## DC Admin

---

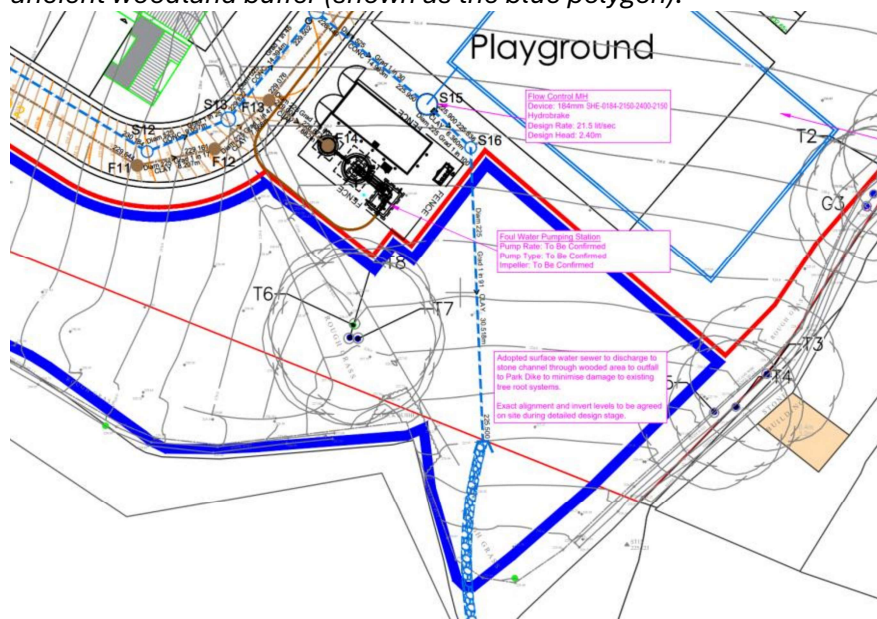
3.7.10 In addition, as the drainage forms part of the scheme, then by reference to government guidance,<sup>18</sup> the redline application boundary should include this infrastructure.

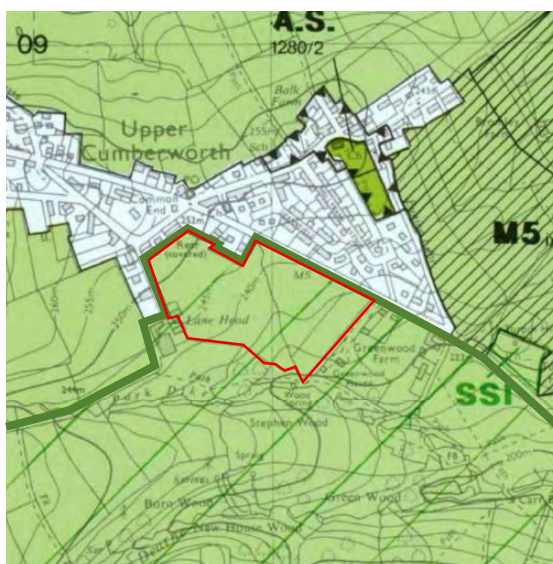
- 4.12 The KDLCA 2015 also replaced the requirement for local landscape designations which had originally formed part of the now superseded Kirklees Unitary Development Plan (UDP) 1999. Originally the site and adjacent area to the east and south was covered by the Policy NE8: Area of High Landscape Value (AHLV). Policy NE8 AHLV was not saved within the adopted Kirklees Local Plan (Feb 2019) because it had been superseded with the KDLCA 2015 which provides a more informative landscape character approach to evaluate value within the landscape. The landscape character approach sets out key characteristics for each LCA which are then evaluated and listed within a table titled: *Valued Landscape Features and Attributes*. Therefore, for further clarification because the AHLV blanket designation (Policy NE8) is not applied anymore, this does not mean that areas of previous designated AHLV (including the site and surrounding area) have been regulated to a lower level of value.
